Subject: Indian Point 3 Nuclear Power Plant
Docket No. 50-286
Additional Information on WCAP-9117

This letter responds to Mr. Schwencer's April 16, 1980 letter requesting additional information to continue the review of WCAP-9117, "Analysis of Reactor Coolant System for Postulated Loss of Coolant Accident: Indian Point 3 Nuclear Power Plant," which was submitted on June 15, 1977 by Consolidated Edison.

ATTACHMENT 1

FIGURE 1

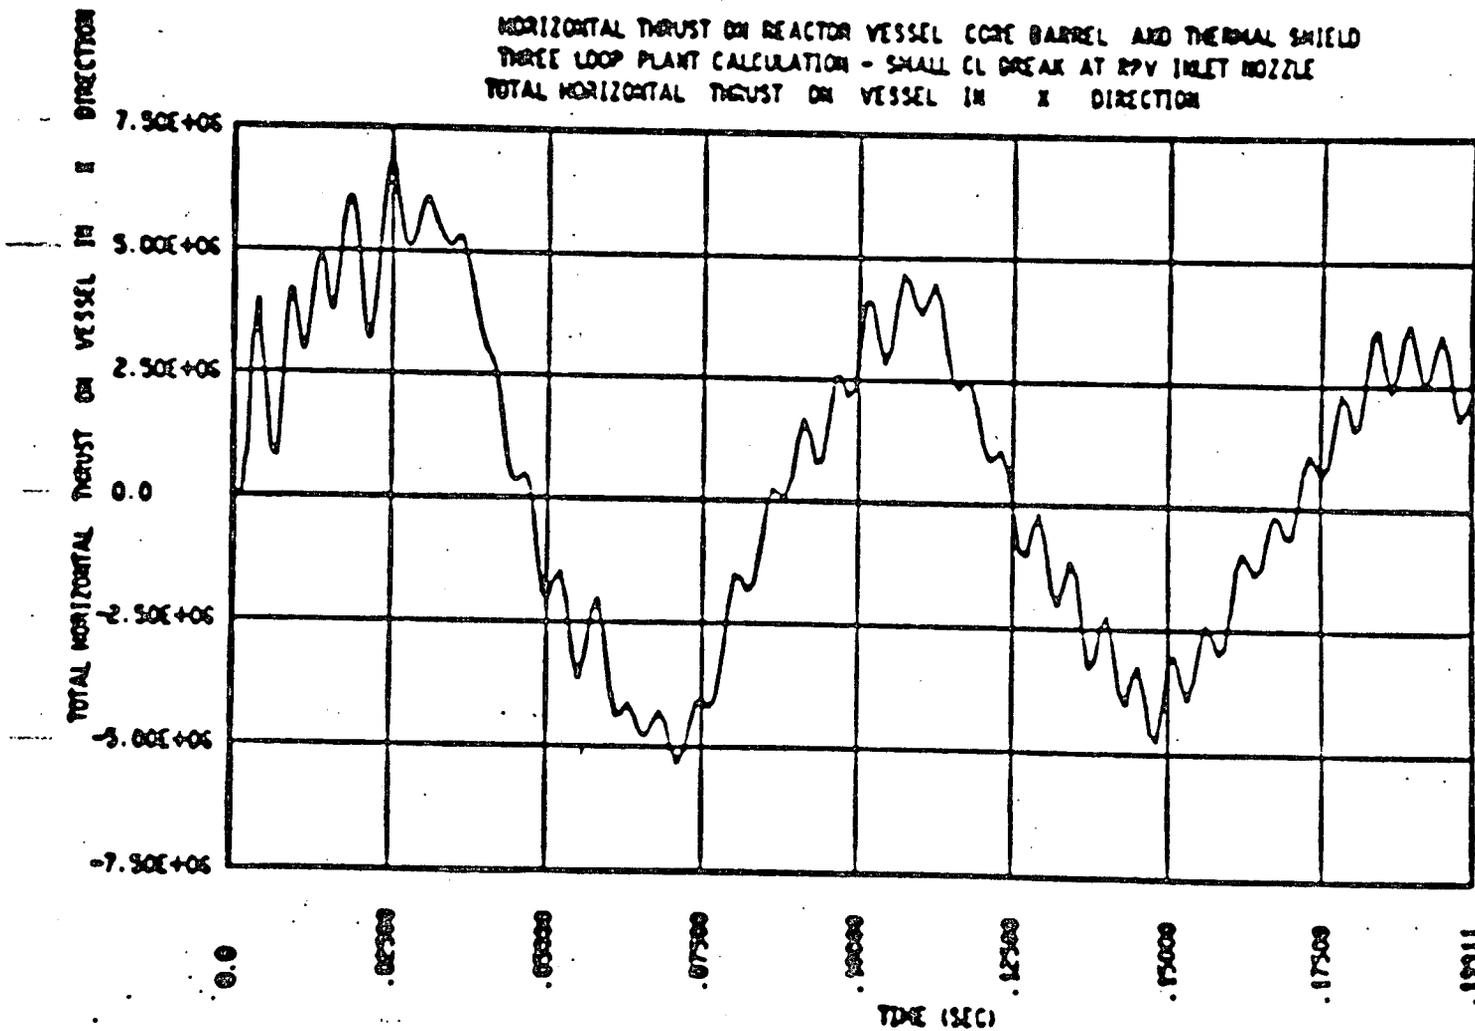
2. What lower plenum radial distance was utilized in the MULTIFLEX representation of the low plenum region of the Indian Point 3 model? Specifically, the comment, Item 2, on Page 12 of the NRC SER on WCAP 8708 should be addressed.

3. What sonic velocity was used in the MULTIFLEX of the Indian Point 3 model? Specifically, the comment, Item 1, on Page 11 of the NRC SER on WCAP 8708 should be addressed.

In the Indian Point No. 3 MULTIFLEX hydraulic model, the equivalent piping network representation of the lower plenum region does not correspond to the NRC modified lower plenum model described on page 12 of the Safety Evaluation Report. Also, the sonic velocity data utilized in the Indian Point No. 3 MULTIFLEX analysis corresponds to the original, uncorrected wave speed.

Parametric studies performed during the NRC review of the MULTIFLEX code demonstrated, however, that the inclusion of a more representative radial transport distance in the lower plenum model and the utilization of updated sonic velocity data results in a maximum of 5% increase in peak total horizontal hydraulic force (THF) on the vessel wall.

In order to further demonstrate the small effect these two modifications have on the hydraulic force, we have performed additional sensitivity studies which consider a limited-displacement area, guillotine-type break at the RPV inlet nozzle. The results of these parametric studies are shown in Figures 1 through 3, which are the THF time-history plots for the three different cases. The peak THF's and the corresponding times they are attained in the transient are given below:

<u>Figure</u>	<u>THF (x 10⁶ lb_f)</u>	<u>Time (Msec)</u>
1	6.786	24.9
2	6.689	22.6
3	7.216	22.5

Comparing Figures 1 and 2 shows that the utilization of the corrected sonic velocity data produced a small reduction (~1.4%) in the maximum THF. A comparison of Figures 1 and 3 demonstrates that the inclusion of a more representative lower plenum model and updated sonic velocity data results in a small increase (~6.3%) in the peak THF. Notice, also, that in all three cases the major forcing function frequency is unchanged.
